SUBDIVISION REVIEW SHEET

CASE NO.: C8-2020-0191.0A

SUBDIVISION NAME: Walton Woods Section 2 Final Plat

CITY OF AUSTIN –DEVELOPMENT SERVICES DEPARTMENT SUBDIVISION APPLICATION – MASTER COMMENT REPORT

WALTON WOODS SECTION 2 FINAL PLAT

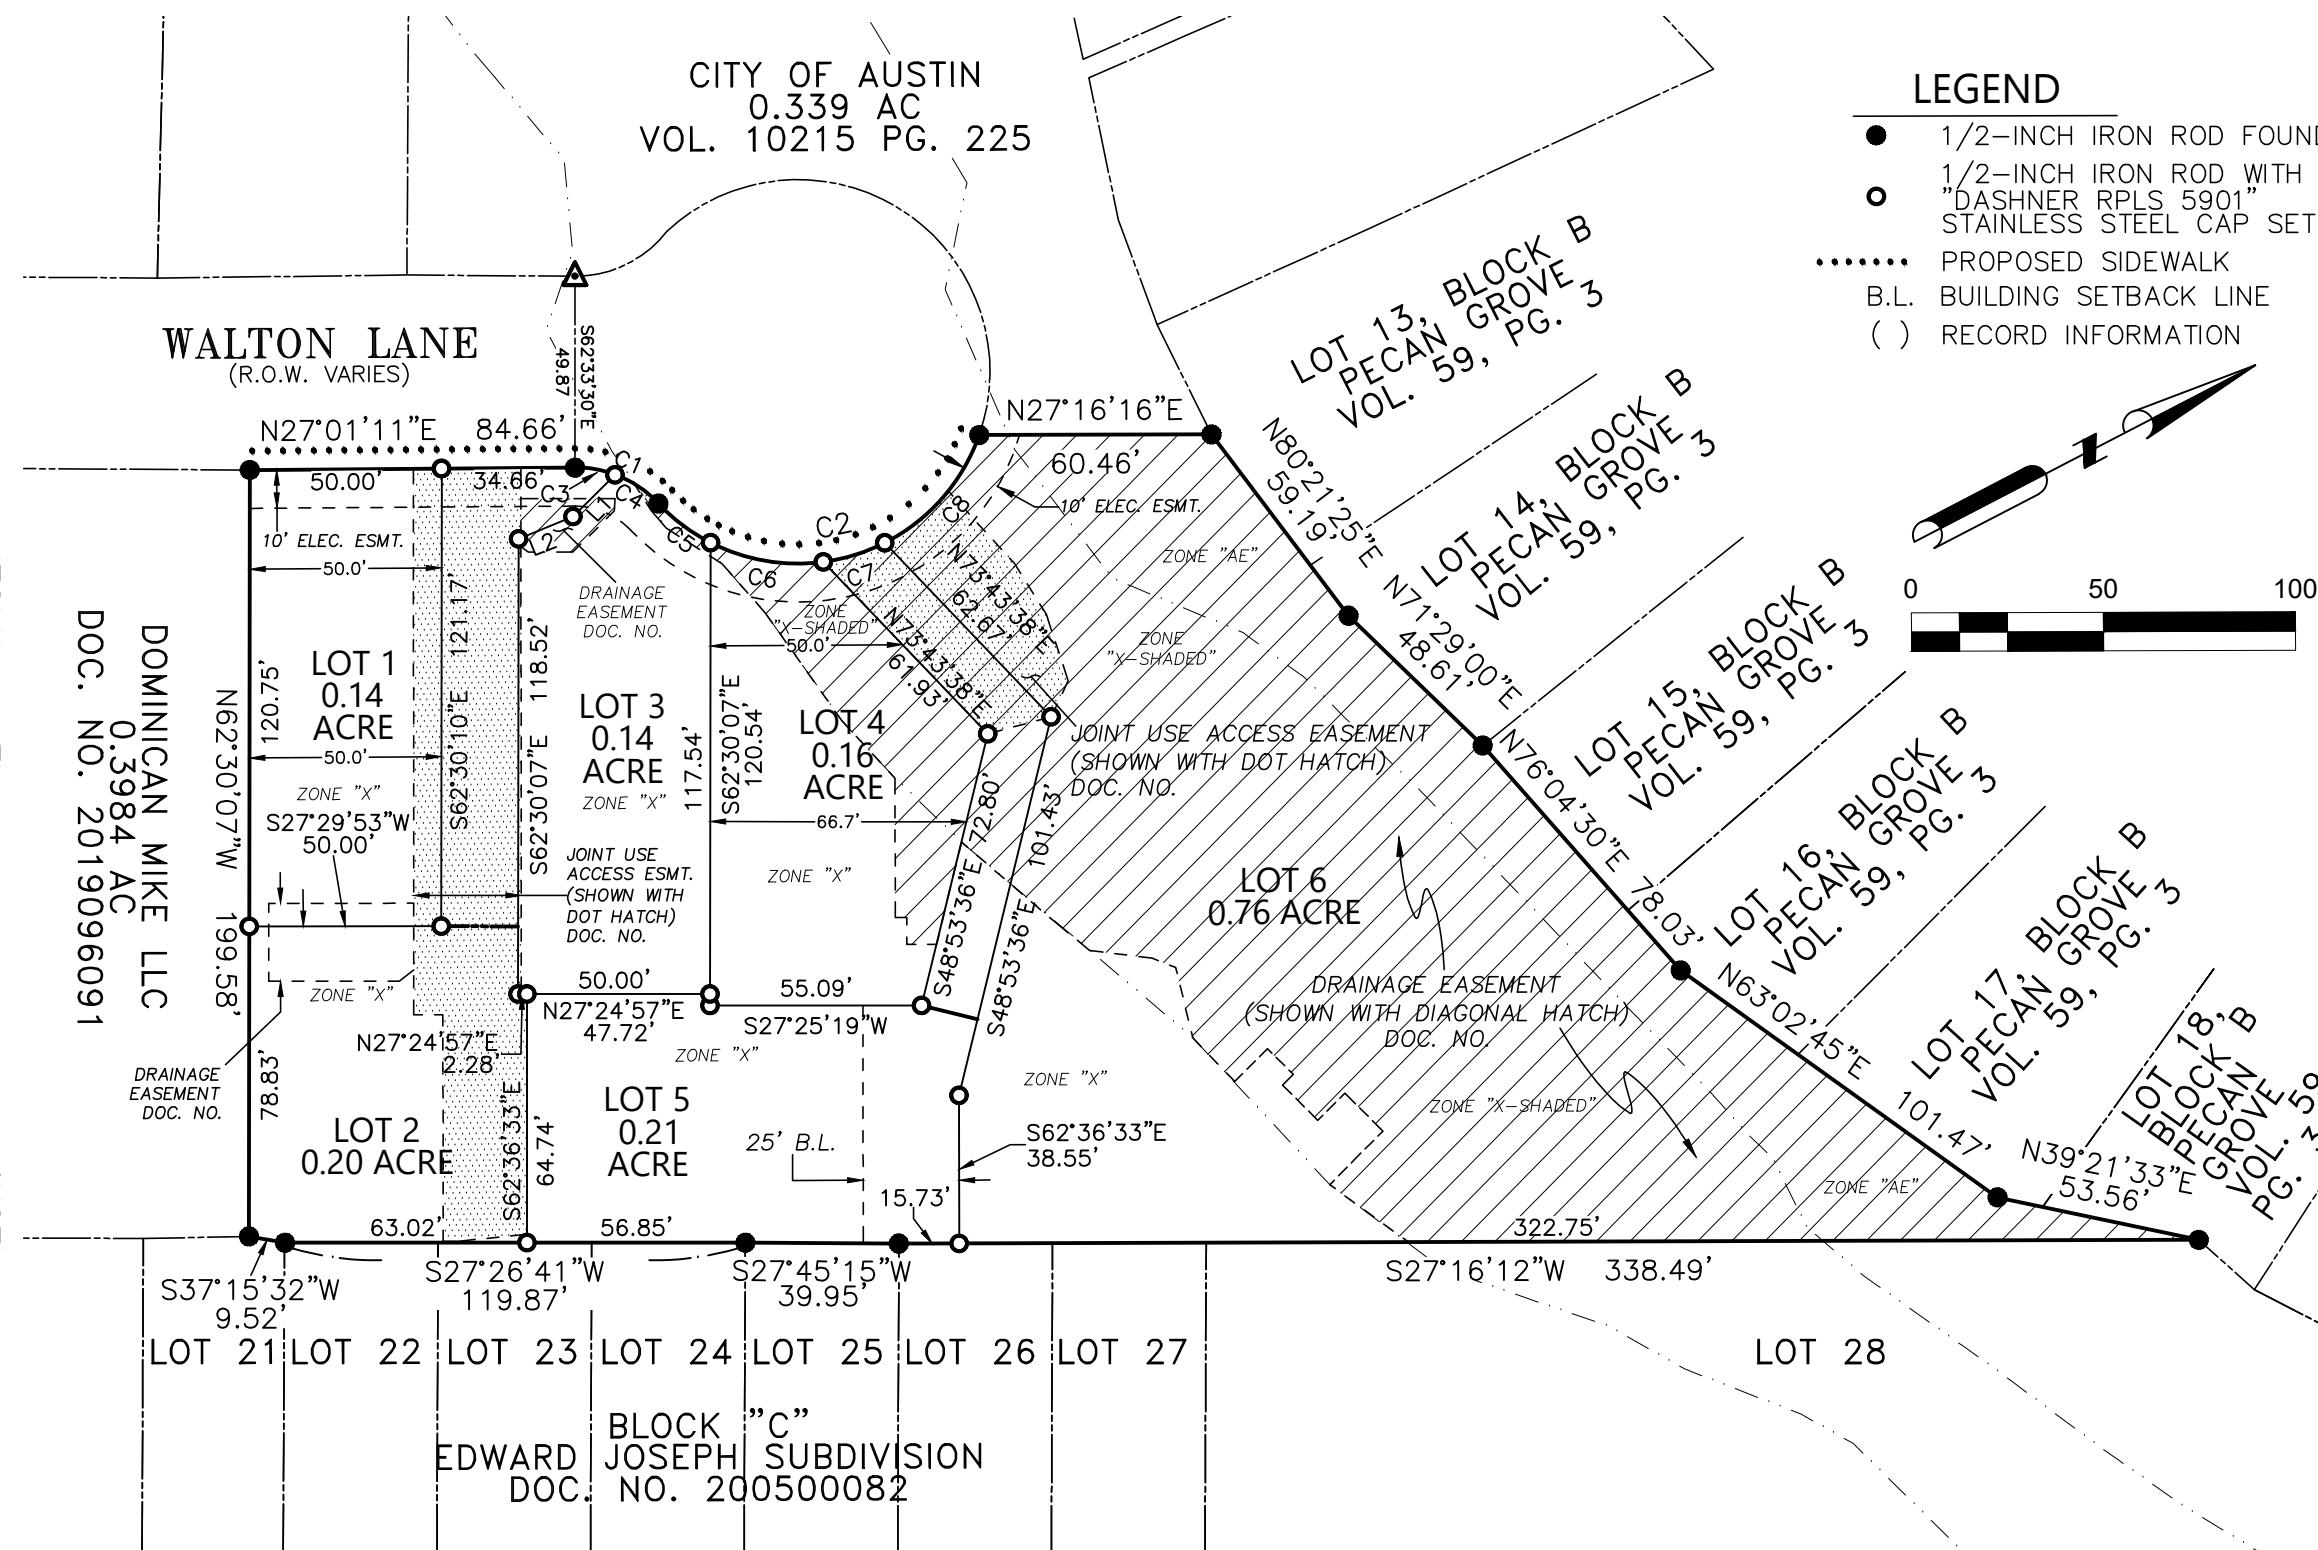
ATD1: Vehicular access to a tract of land through a joint-use driveway is permitted as an alternative to direct access to an abutting public or private street. LDC 25-6-451(B). The use of joint use driveways does not eliminate the requirements of adequate road frontage for each lot. The developer must include a plat note and provide dedication documents indicating that maintenance of the joint use access shall be the responsibility of the lot owners served by the joint use access. TCM 5.3.1.H. Please dimension joint use easement on the plat.

- PR 1: Parkland dedication is required per Chapter 25-1, Article 14 (Parkland Dedication) of the City Code prior to approval of this plat. You provided the Parkland Early Determination letter that specifies that PARD will be taking land. However Note 14 suggest that PLD will be satisfied by fees-in-lieu. Please remove this note. Show parkland along Boggy Creek. PARD will take all of your floodplain, and enough upland/unencumbered area for access to build and maintain a 10' improved surface trail. In order to calculate credit for the land you will be providing, provide to this reviewer a table showing the acreages of parkland dedication that is in the following categories: (A) 25-year floodplain, (B) critical water quality zone, 100-year floodplain, or CEF buffer NOT in 25-year floodplain, and (C) land unencumbered by the above mentioned restrictions.

- PR 2: Update Note 14 with the following "parkland dedication has been satisfied by the dedication of XX acres labeled on the plat as Parkland Dedicated to City of Austin, as well as the payment of fees-in-lieu."

SR 1. Revise the surveyor's certification as follows 25-1-83, 30-1-113:

SR 2. In the director's approval block updated the listed year to 2022.

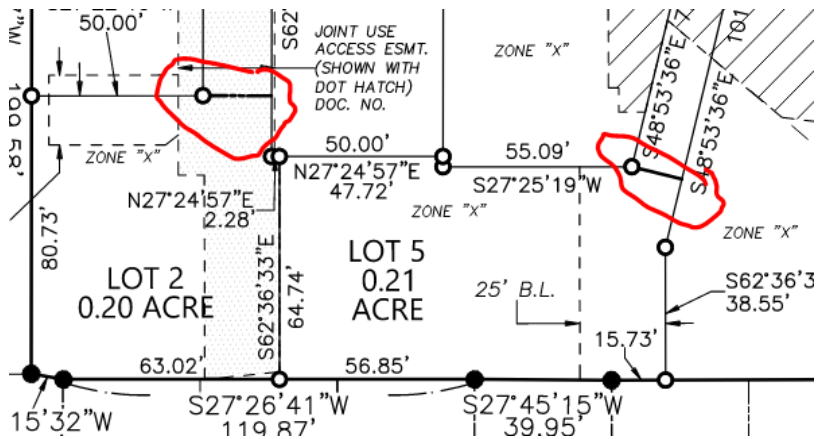
SR 4. For Lot 2 and Lot 5, annotate the dashed line between the buildable area or pole (access strip) for each lot, if these lines are annotating an area the lines should be dashed line. Or, remove the dashed line and solid lines in the lot areas. Solid lines on plats are only used to show lot boundaries.
